POLICY REPORT
DEVELOPMENT AND BUILDING

Report Date: January 6, 2015
Contact: Susan Haid
Contact No.: 604.871.6431
RTS No.: 10758
VanRIMS No.: 08-2000-20
Meeting Date: January 20, 2015

TO: Vancouver City Council
FROM: General Manager of Planning and Development Services
SUBJECT: CD-1 Rezoning: 5430-5450 Oak Street

Site / Landscape Plan

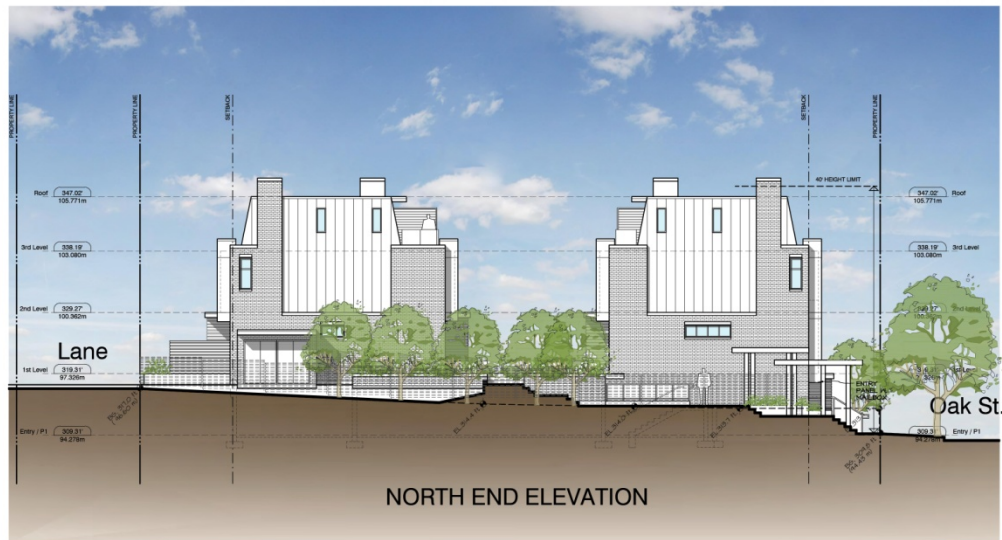
- 1. Design development to provide a clearer distinction between the public and private realm at the front entries along Oak Street.

- 2. Design development to provide improved animation and articulation of the lane edge by providing entries to the patios at the rear units.

- 3. Design development to the semi-private courtyard to provide improved opportunities for social interaction and informal children's play.

12. Provision of large-scale landscape sections (typical) through planted areas, including the slab-patio-planter relationship, the lane interface, common areas and upper levels.

14. Clearly show first step risers a minimum of 1'-0" back from the ultimate property line on the site and landscape plans (i.e. following the dedication along Oak Street).
15. Clearly show the dedication line on the landscape plan and ensure there are no landscaping features or encroachments other than those that meet with the boulevard landscaping guidelines shown beyond the dedication line and they do not interfere with the proposed sidewalk widths.

Note to Applicant: This may be achieved by providing an elevated main floor and entry and/or a more robust fence detail. The fence should not be entirely solid, but should incorporate transparent panels to provide views through and contribute to pedestrian visual interest. Fence height at the front yard is limited to 4 feet.

Note to Applicant: The rear patio walls should be further articulated to add visual interest and a sense of scale. At-grade landscaping and planters should continue to be incorporated into the wall design. A section and elevation detail should be provided to illustrate the lane entry and wall treatment for a typical townhouse module.

Note to Applicant: This may be achieved by creating areas of special interest and focus along common pathways as part of the overall landscape design.

Note to Applicant: The sections should include the planter materials, tree stem, canopy and root ball.
